SERVICE BULLETIN

EC09-010

2004 – 2005 ALTIMA; DTC P0420 WITH SULEV QR25DE ENGINE

APPLIED VEHICLES: 2004-2005 Altima (L31)

Figure 2

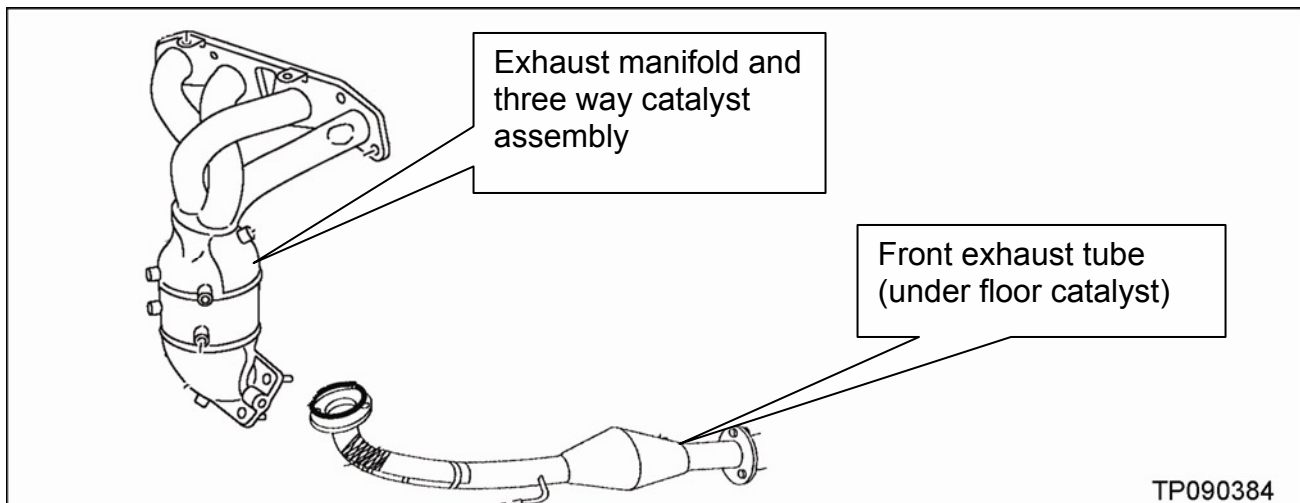
3. Install the Repair Kit listed in the Parts Information.

- Repair Kit includes exhaust manifold and three way catalyst assembly and the front exhaust tube (under floor catalyst).
- Refer to the Service Manual as needed for replacement information.
- **Make sure to use the parts listed in the Parts Information of this bulletin.**
- Transfer heat shields and sensors from the old manifold and front tube to the new ones.
- Replace gaskets, seals, and nuts supplied in the Repair Kit.
